Commonwealth Edison Company  
Byron/Braidwood Units 1 and 2  
Relaxation of MSSV Setpoint Tolerance to +/-3% - Revised SECL

Enclosed please find Revision 1 to safety evaluation SECL 90-469, previously transmitted via Reference 1. The revised safety evaluation clarifies the section of the ASME code associated with the main steam safety valves.

WESTINGHOUSE NUCLEAR SAFETY  
SAFETY EVALUATION CHECK LIST

APPENDIX B  
UFSAR MARKUPS

FIGURE 15.2-3

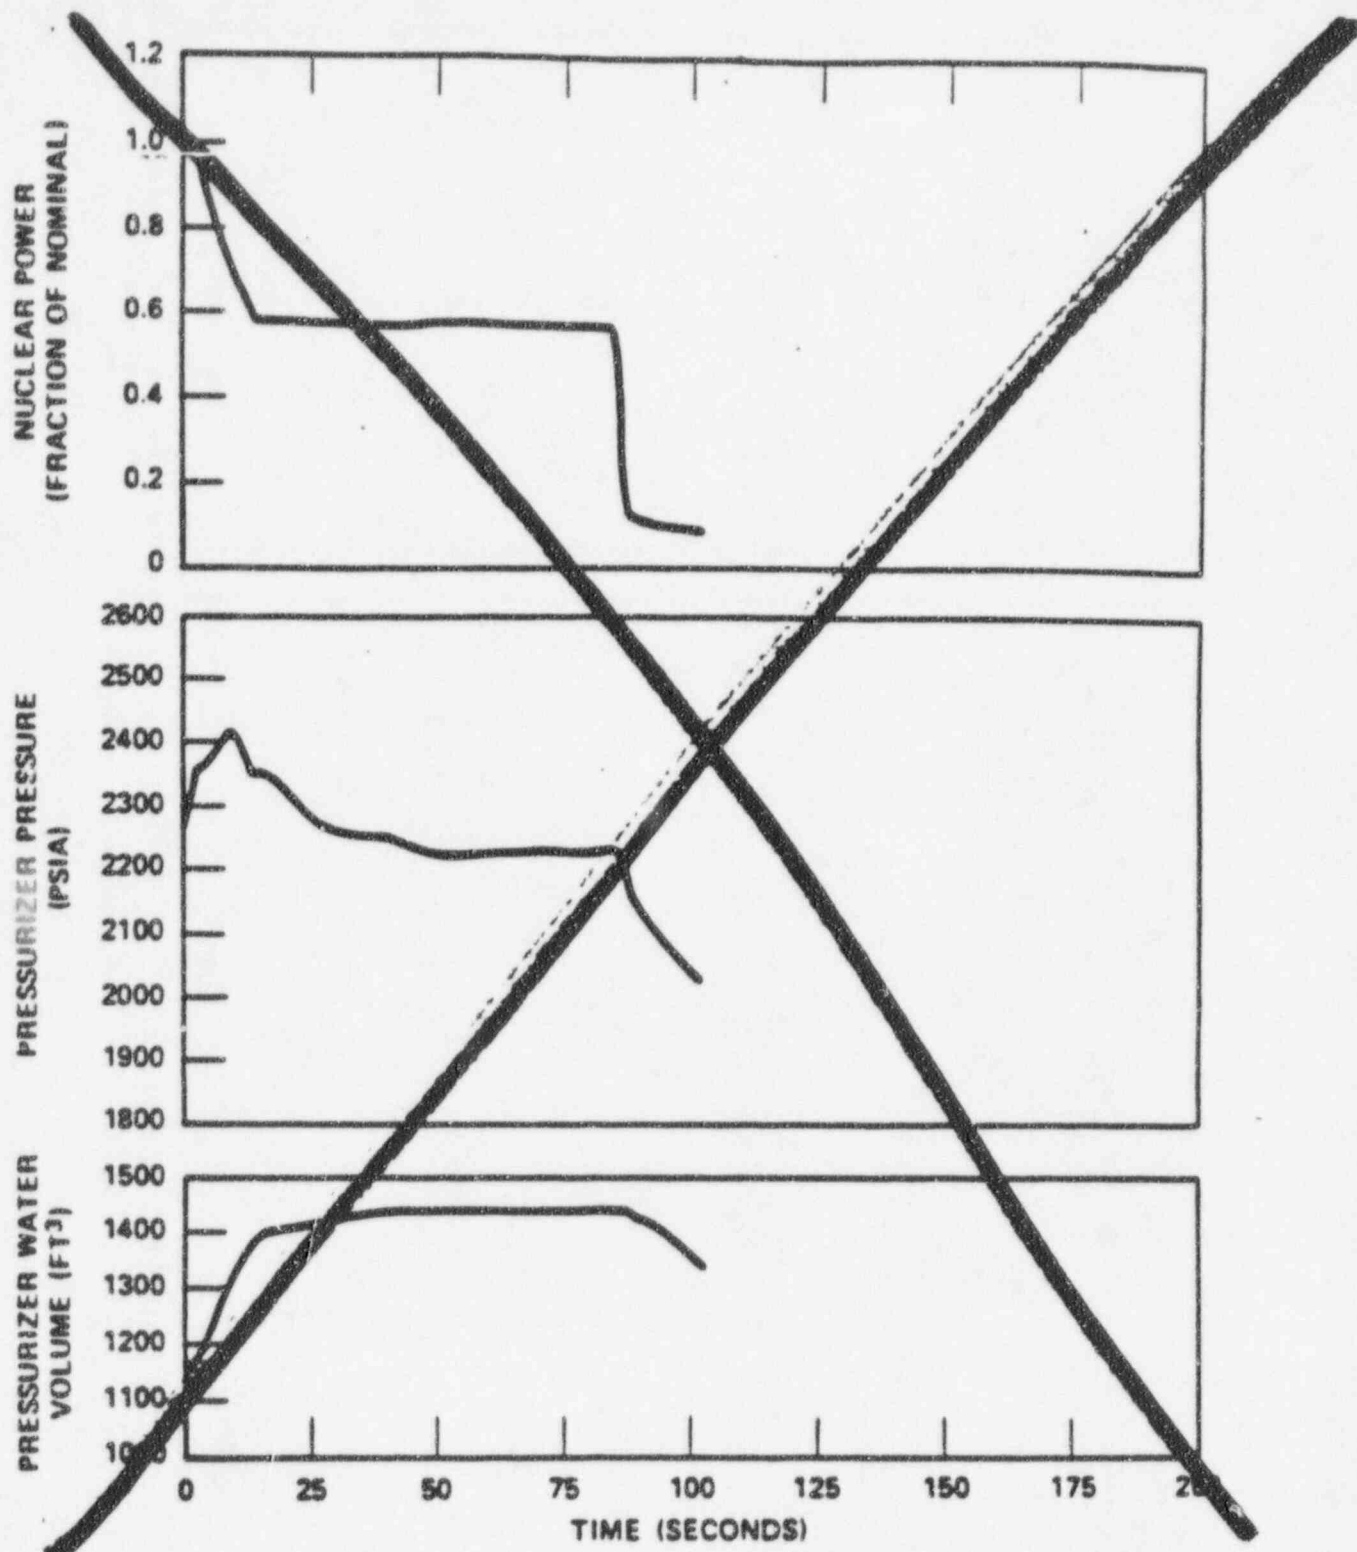
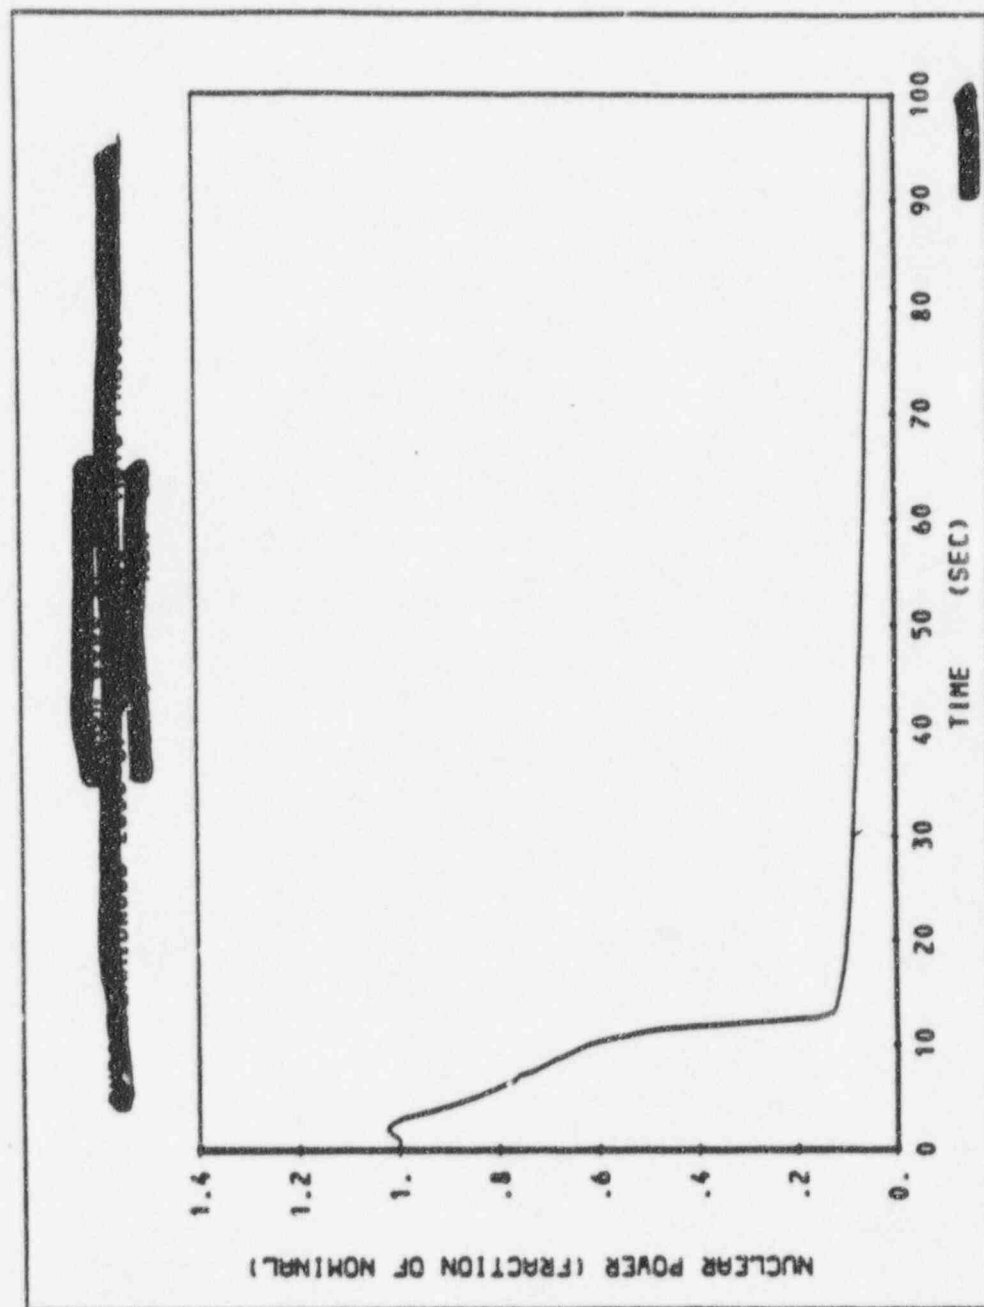
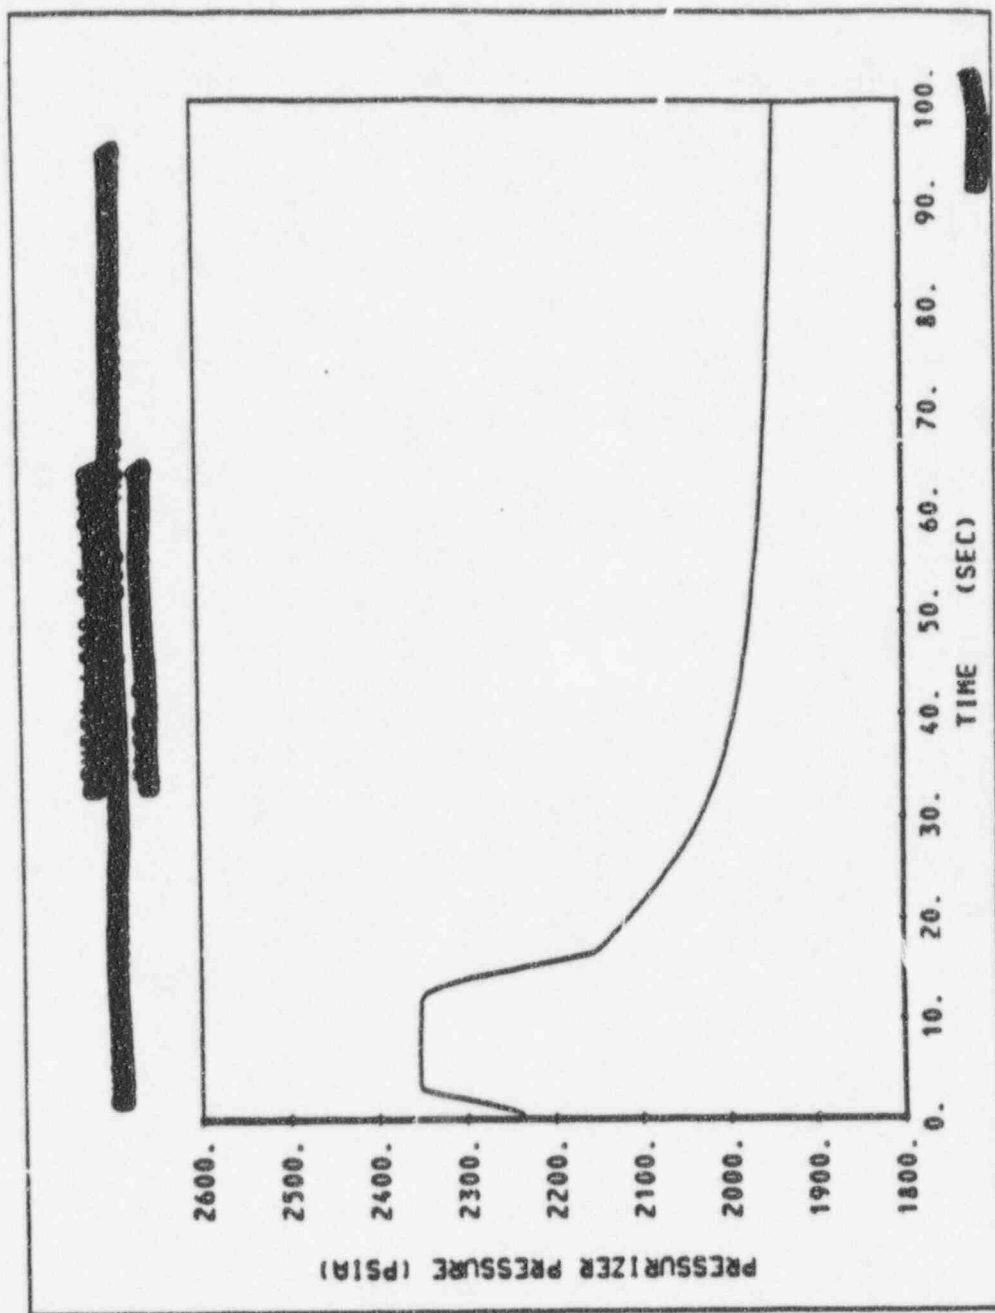
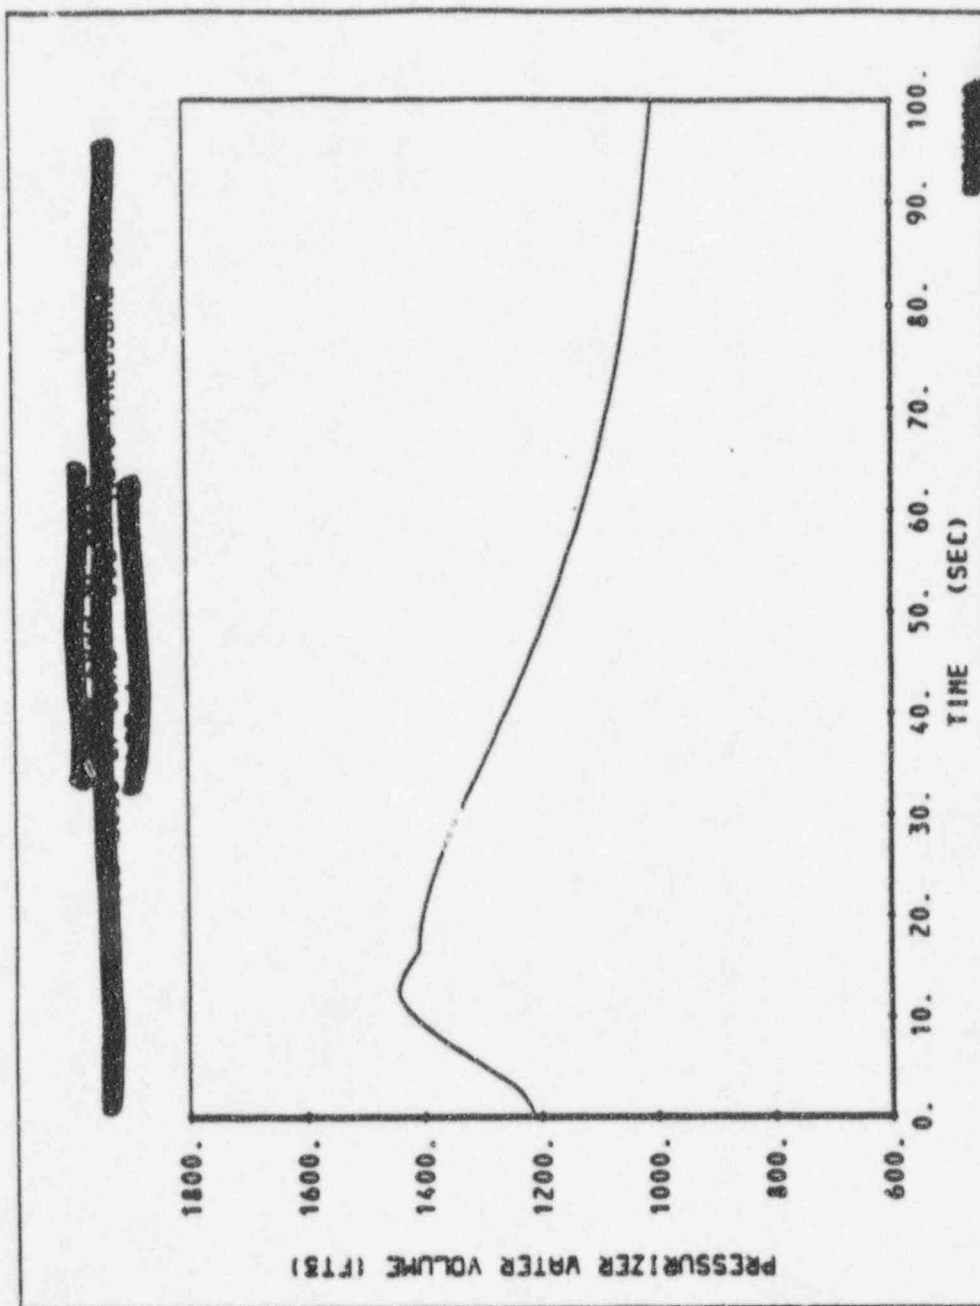
Figures 15.2-3 and 15.2-4 show the response for the total loss of steam load with a large negative moderator temperature coefficient. All other plant parameters are the same as the above. The DNBR increases throughout the transient and never drops below its initial value. Pressurizer relief valves and steam generator

REPLACE WITH  
the following  
Figures
